TECHNICAL BULLETIN
Bell Helicopter **TEXTRON**

No. 407-03-48

MODEL AFFECTED: Model 407

SUBJECT: MAIN ROTOR CONE SET 407-010-114-101
SHIMMING PROCEDURE INTRODUCTION OF.

Figure 4. Shims installation

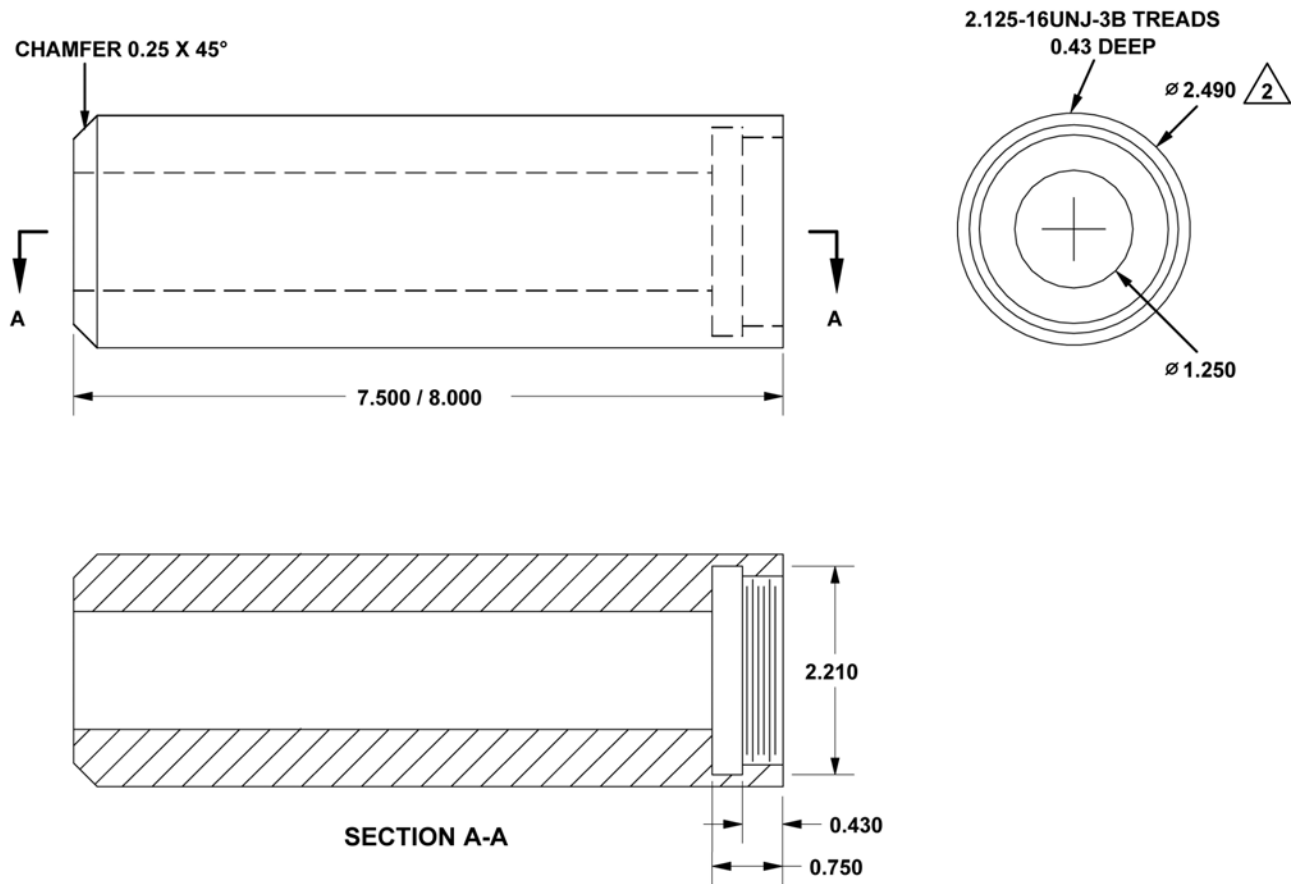
- g. Apply a light film of THIXOGREASE (C-561) to the inside diameter of the cone set and install on the mast with the two shims. The two shims or the cone set split line axis should be at 90 degrees with the master spline. Refer to the Figure 4 Note 1.
- h. Make sure that the cone set and the shims are firmly attached to the mast with two single wraps of 0.032 inch safety wire (C-405) and that no gap exists between the cone set and the mast as indicated on the Figure 3 Note 1.

- i. Bend the safety wires twisted ends as shown on the Figure 4 and tuck the “pigtails” as shown in detail A.
- j. After final cone set installation ensure that the cone set with the shims are firmly attached to the mast and that it is not allowed to move in any direction with light hand pressure only. If the cone set is loose on the mast redo the shimming.
- k. Install the work aid on the mast nut threads and proceed with normal main rotor hub assembly installation. Refer to the BHT-407-MM Chapter 62 or to the TB 407-99-16.

- (1) Shims are to be installed at 90° to the Master Spline and inline between two splines.
- (2) Hub Alignment Work Aid can be locally manufactured or procured from Paravion Technology under part number T0001
Paravion Technology Inc.
2001 Airway avenue
Fort Collins, CO. 80524
USA.
Phone: (970) 224-3898
Fax.: (970) 224-3899
E Mail: paravion@paravion.com
- (3) Make sure the Safety Wires pigtail is properly tucked in the cavity.
- (4) Thixogrease NLGI No. 2 replaces the corrosion preventive compound MIL-C-16173 Gr 2. at all locations indicated in the Maintenance Manual, Chapter 62 and the TB 407-99-16 for the main rotor hub assembly installation.

Figure 1. Work aid

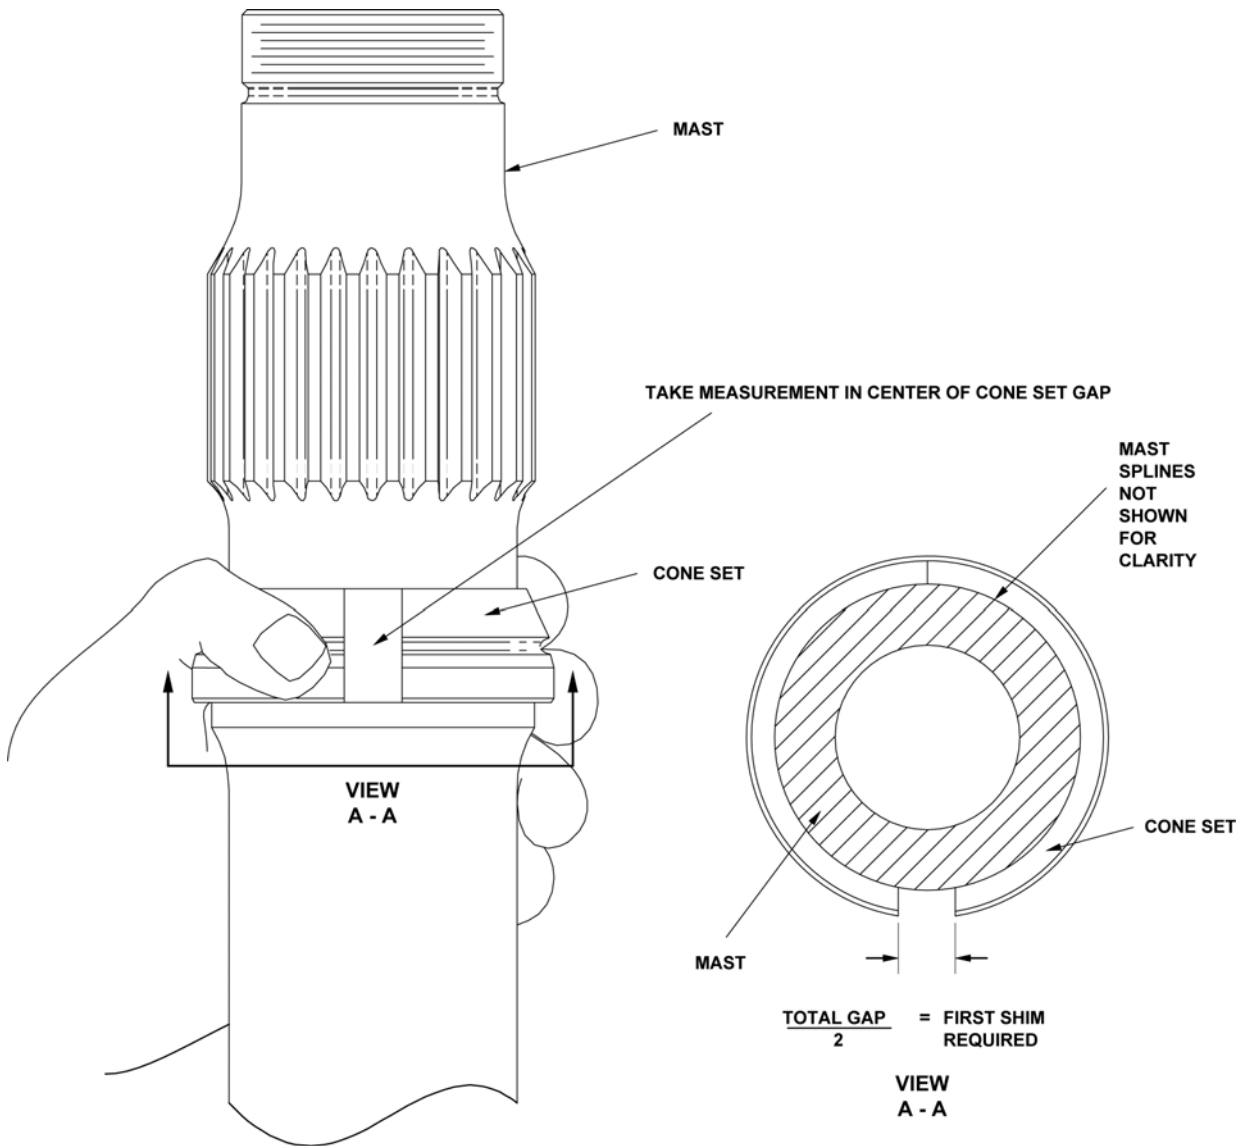
The use of the work aid (hub alignment tool) shown on the figure 4 is optional but recommended to avoid contact of the lower cone seat with the cone set as the hub assembly is lowered on the mast. This work aid can be locally manufactured using the instructions provided on the Figure 1 or procured from Paravion Technology Inc. under the part number T0001.

1. This work aid can be locally manufactured or procured through Paravion Technology under part number T0001.

- 2** Inside diameter to outside diameter concentricity to be within 0.002 inch.

Figure 2. First shim required

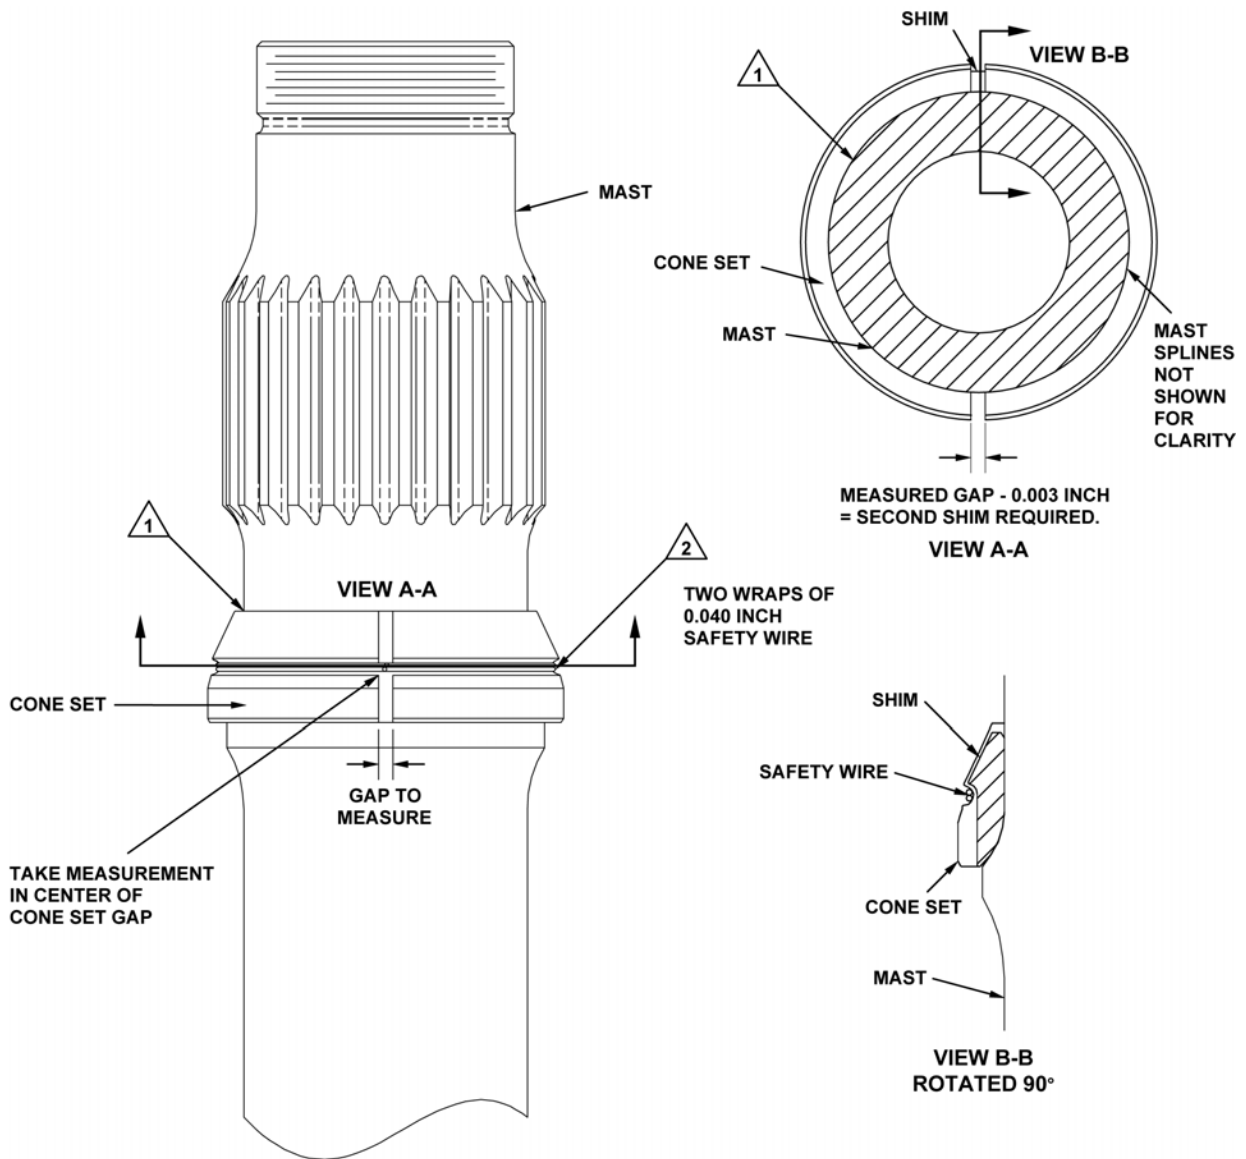
1. Remove the main rotor blades and the main rotor hub assembly from the helicopter. Refer to the BHT-407-MM-6, Chapter 62.
2. Remove the 407-010-114-101 cone set from the mast and inspect for general condition. If the cone set has “flat spots” or has excessive wear on the inside diameter radius replace the cone set.
3. Use Aliphatic Naphta (C-305) and thoroughly clean the mast and the cone set to remove all Corrosion Preventive Compound.
4. Measure and calculate the thickness of the first required shim as follow:
 - a. Install the cone set on the mast and hold in place by hand as shown on the Figure 2 to close the gap on one side.
 - b. Using a caliper measure the remaining gap. Take the measurement at the center of the gap.
 - c. Divide the dimension obtained in step b. by two. This is the thickness of the first required shim.

- d. Peel the shim to the closest dimension calculated in step c. As an example, if the calculated shim thickness required is 0.127 inch peel shim to obtain this dimension +/- 0.003 inch.
5. Measure the thickness of the second required shim as follow:

Figure 3. Second shim required

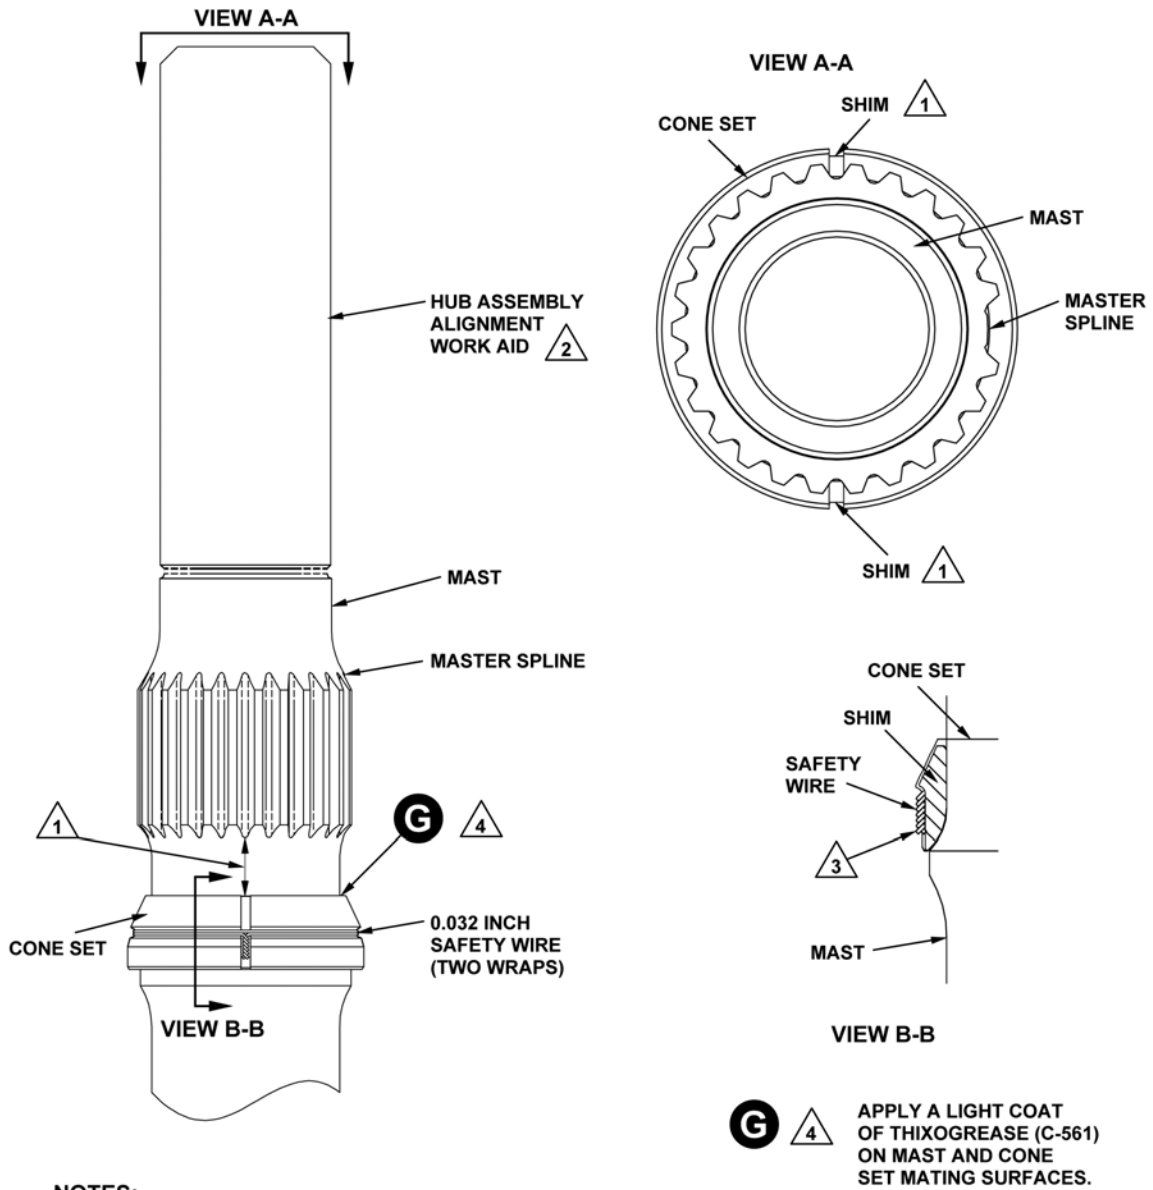
- a. Temporary install the cone set on the mast with two wraps of 0.040 inch safety wire (C-447). Refer to Figure 3. The 0.040 inch safety wire is used in this step only to ensure that the 407-010-114 cone set is firmly in contact with the mast and that no gap exist all around. It might also be required to use a "C" clamp to ensure that no gap exist between the mast and the cone set as shown on the Figure 3.

- b. Install the first shim in one split as shown on the Figure 3. Make sure the two cone set halves are well in contact with the first installed shim and that they are still in firm contact with the mast.

- c. Use a caliper and measure the gap between the two cone set halves in the center of the gap.
- d. Record the dimension obtained in step c. and subtracts this number by 0.003 inch. This number is the maximum amount of shims to be installed. The intent is to have a minimum loose fit of the second shim of 0.003 inch. As an example if the dimension measured in step c. is 0.128 inch the required shim thickness will be 0.125 inch. Since the shim has 0.003 inch laminates the required shim will be peeled to approximately 0.123 inch. If the dimension measured is 0.120 inch the required shim dimension is 0.117 inch. In this case the shim would need to be peeled to approximately 0.117 inch.

- e. Temporary install the second shim in the remaining gap to verify the fit. The shim should be slightly loose (0.003 inch) in the gap and the cone set should be in firm contact with the mast. Make sure that no gap exists between the cone set and the mast as indicated on the Figure 3 Note 1.

- 1 Make sure no gap exists between the Cone Set halves and the Mast.
- 2 Two wraps of 0.040 inch Safety Wire are used in this temporary installation to ensure a firm contact of the Cone Set on the Mast. In addition to the safety wire a "C" clamp may also be used to make sure that no gap exists as directed in note 1.
